170 Little Marine Parade

# PROPOSED NEW TWO STOREY HOUSE AT 170 LITTLE MARINE PARADE, COTTESLOE

Re: Development Application- #2944, 170 little Marine Pde, Cottesloe, Planning Application for a Two Storey Dwelling

#### RE: Planning Application, 170 Little Marine Parade, Cottesloe WA

## 5. The west facing Master Bedroom Window

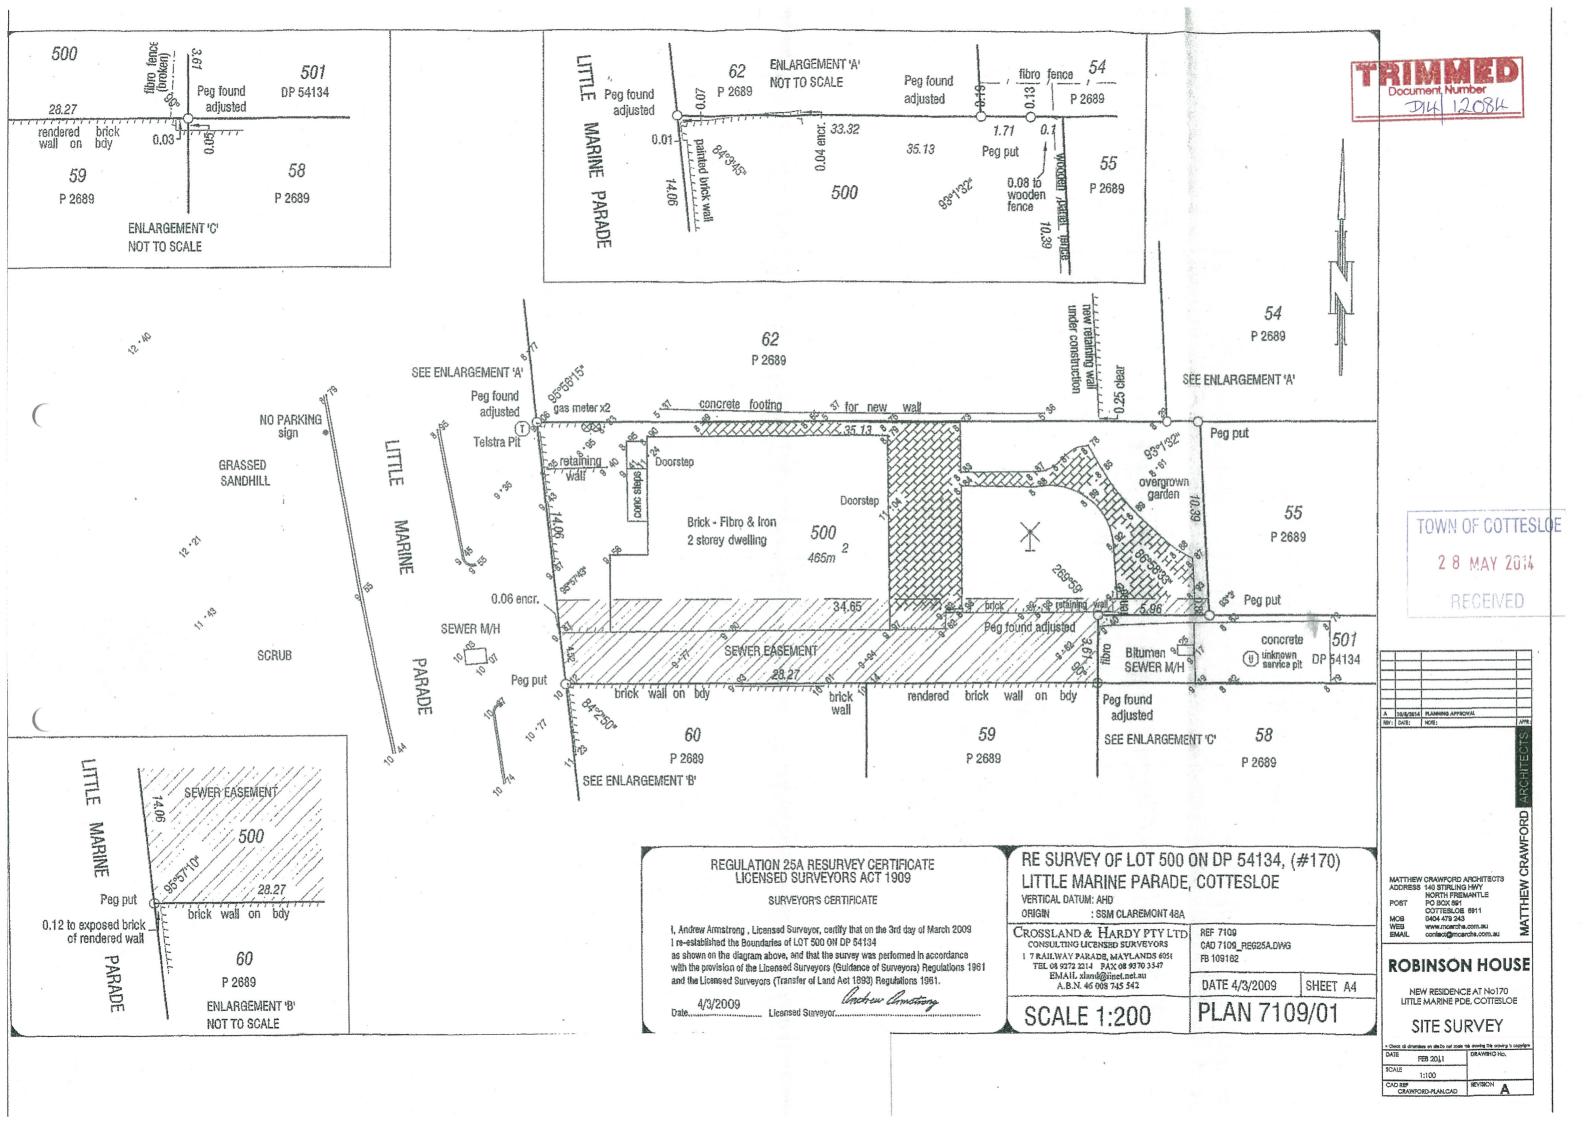
The proposed window to the master bedroom is larger than one square metre, therefore should be considered a major opening.

The proposed window contravenes performance criteria of the R Codes, section 6.8 regarding privacy requirements. The window directly overlooks a ground floor bedroom located at the front of our property. We request consideration that it be screened (such as to the window's north side and bottom edge)or has opaque glass to a level providing privacy or it becomes a minor opening.

**GROUND FLOOR & SITE PLAN**

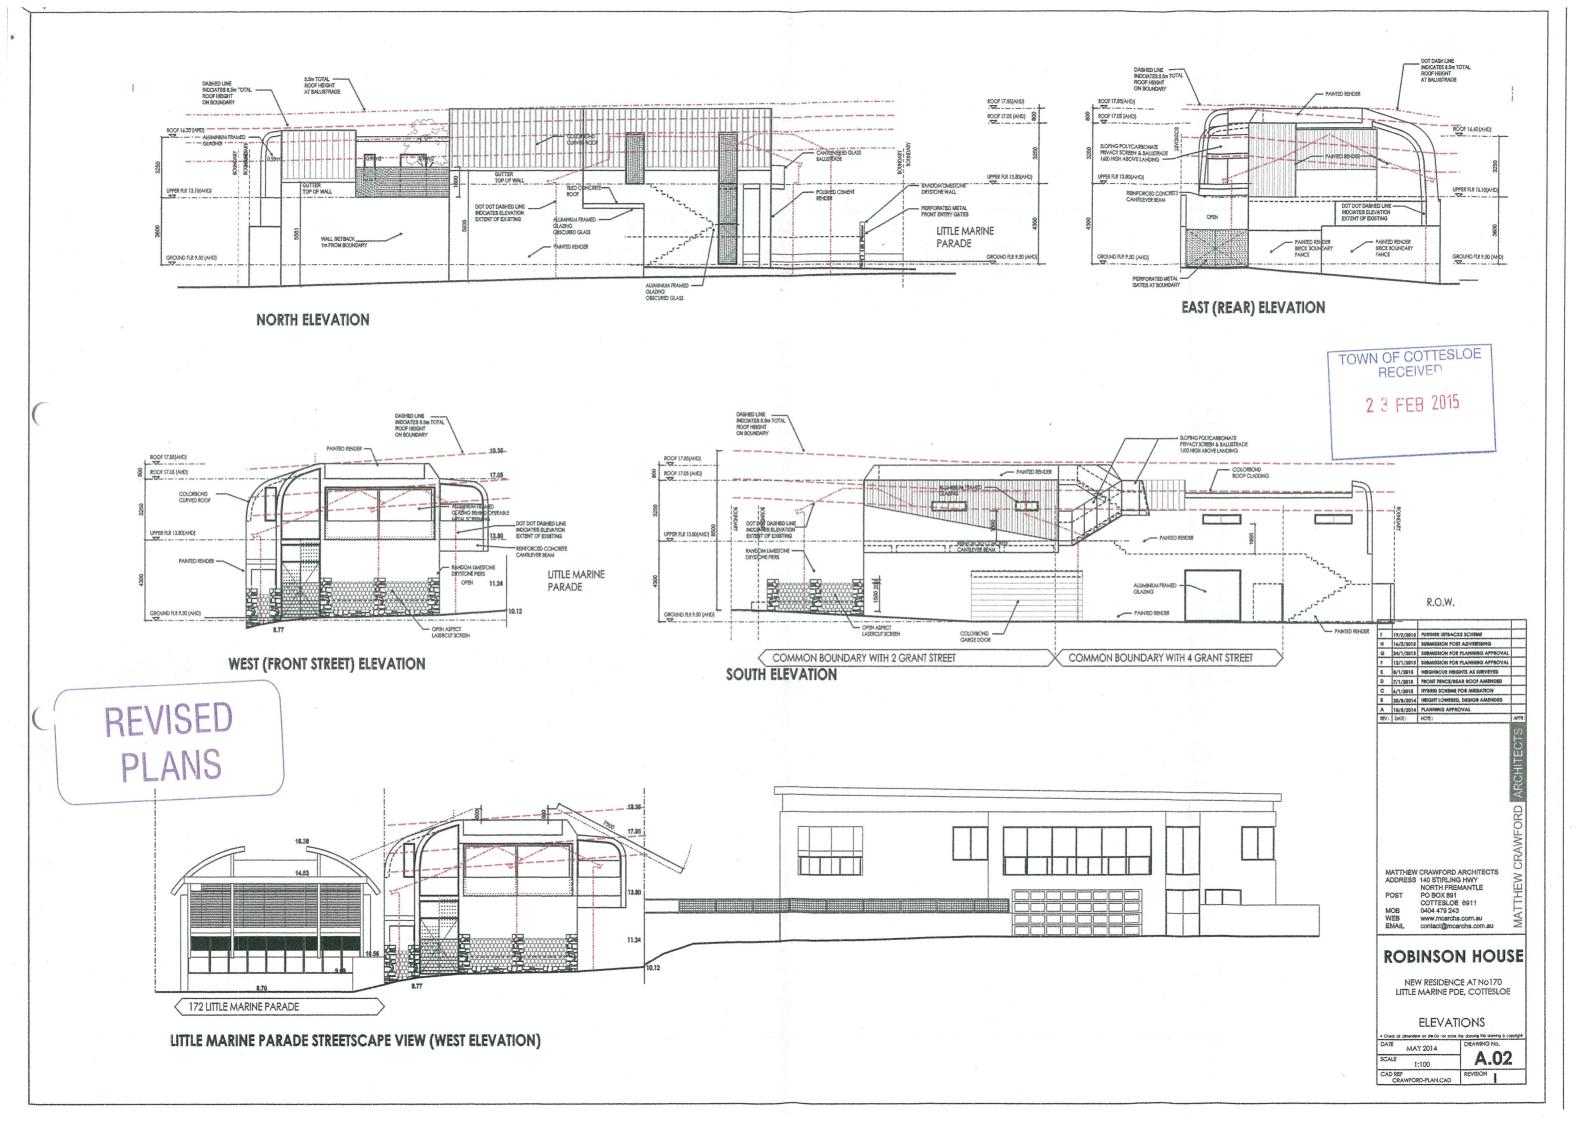
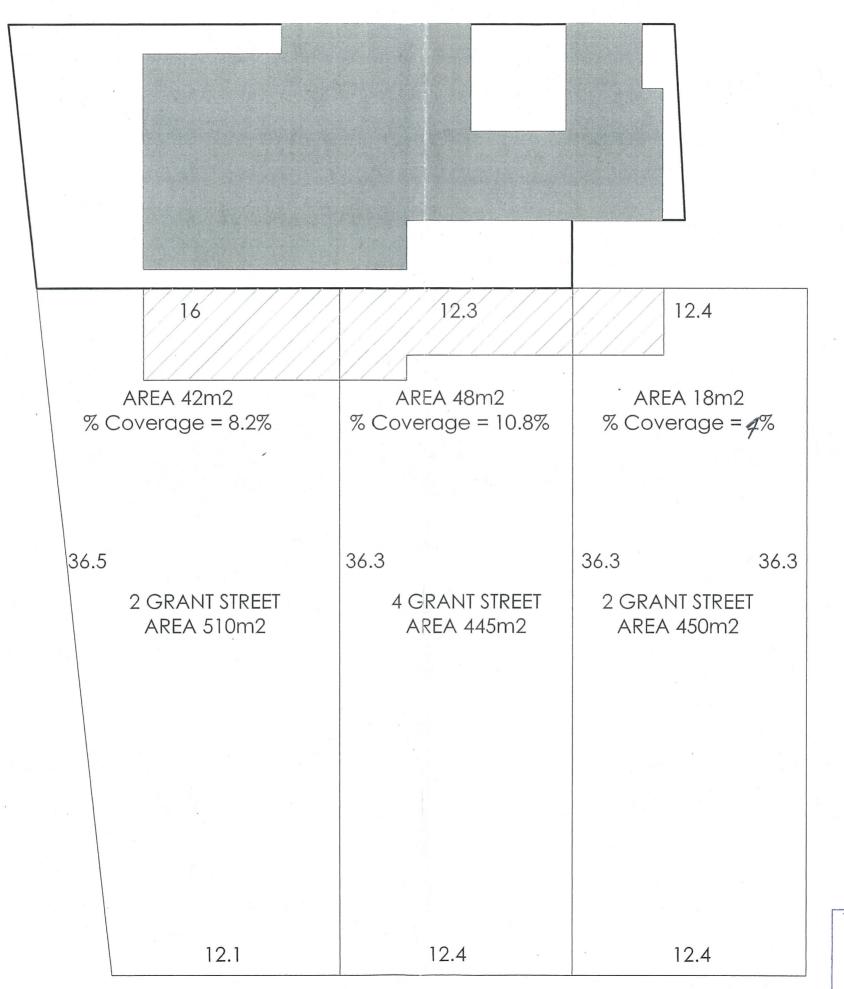
- a) The excessive bulk on our southern boundary (length and height) that far exceeds building guidelines and will have an adverse effect on our property.

- The proposed parapet wall on this boundary is approximately 20m in length and it is 6m high for 11m of this. Then there are 2 roof elements of 4m and 7.2m that rise nearly vertically before curving away. These effectively add another metre to the height of the parapet walls in these locations and when the wall and roof elements are combined, we will visually have a wall/roof on our boundary of 7m height in these sections.

- b) Added to this, there is a roof garden on the 1<sup>st</sup> floor joining the parapet wall that is shown without privacy screening. When a 1.6m privacy screen is included then the length and height of the proposed parapet wall and privacy screen would be 6m high for 16m in length. (Plus a lower parapet wall of 3.9m height)

- d) I am concerned that the roof top terrace will overlook our roof top terrace and spa as the walls are only 1.3m. There is not enough detail on the plans to determine this accurately. (Our roof top terrace has 1.6m walls and does not overlook any neighbours).

- e) The plans have drawn our property incorrectly-they show our roof touching the boundary and our house situated closer than it is. This gives an incorrect visual representation of the 2 properties next to each other and as such should not be used to assess the impact of the proposed planning application on our property.

A.01

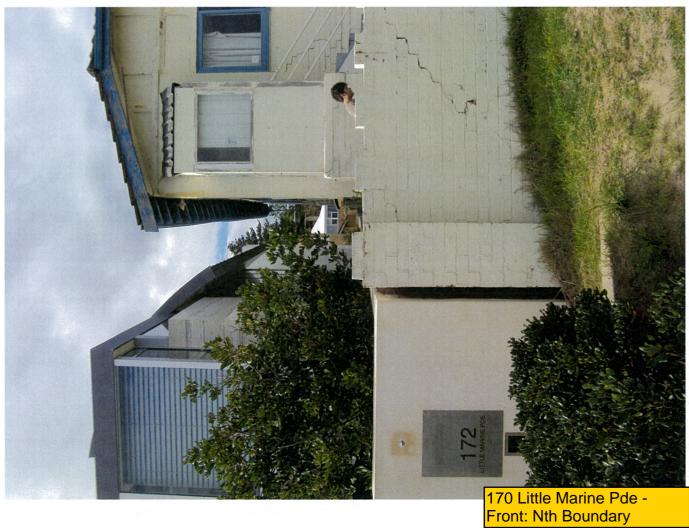
1) I saw changes to the parapet wall but did not see and changes to the roof top terrace and are still concerned about the privacy. In fact as you are aware, the lack of information on the plans created more questions eg what is the actual height of the walls of the roof terrace?

As mentioned yesterday some sort of privacy screening, if allowed, in the northern corner of the Roof Top Terrace could solve this problem.

J 12/3/2015 PRIVACY SCREENS ADDED
I 19/2/2015 FURTHER SETBACKS SCHEM
